Office Action Summary	Application No. 10/626,106	Applicant(s) HAATAJA ET AL.	
	Examiner Marc Jimenez	Art Unit 3726

DETAILED ACTION

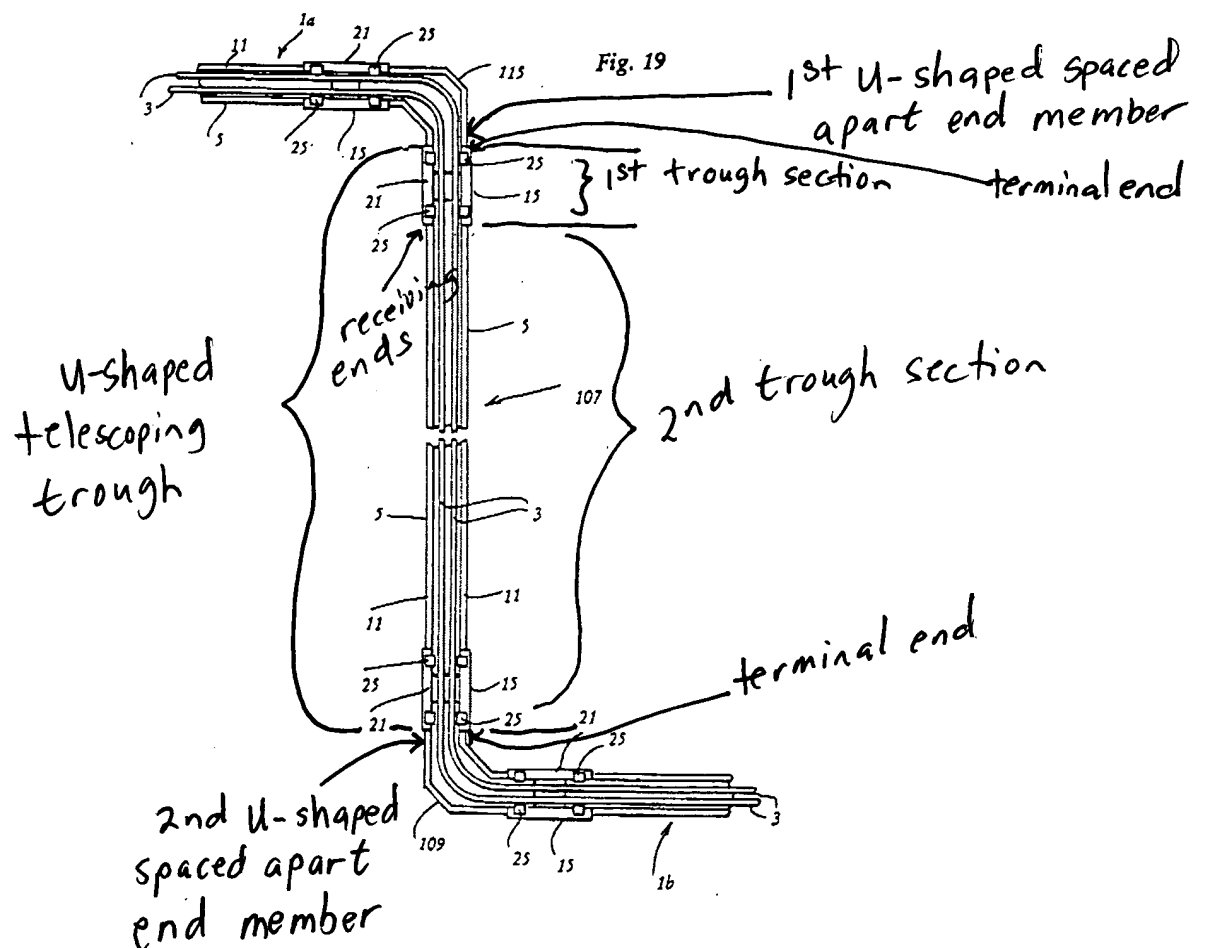
Regarding claims 1-4, Zetena teaches the following in figure 19: first **115** and second **109** U-shaped spaced apart members, providing a telescoping U-shaped trough with first and second trough sections (See mark-up of figure 19 below for what is considered “first” and “second” trough “sections”), the first and second trough sections each having a terminal end **21** and a receiving end (See mark-up of figure 19 below for what is considered “receiving ends”), the

receiving ends of the first and second trough sections being in sliding contact with one another, the terminal ends **21** of the first and second trough sections having the same connecting configuration such that the telescoping U-shaped trough is reversible, positioning the reversible telescoping U-shaped trough between the first and second end members **115,109**, and connecting the first and second trough sections of the reversible telescoping U-shaped trough to the first and second end members **115,109**, wherein the first and second trough sections remain freely slideable upon disconnecting at least one of the first and second trough sections from the respective first and second end members **115,109**.

Regarding claims 20-23, 26 and 27, Zetena is considered to meet the "sliding movement of the first and second trough sections being limited between a minimum extension position and a maximum extension position to prevent sliding separating of the first and second trough sections" limitation because the trough member is locked in place by locking clips **25**. The clips **25** are also considered "stops".
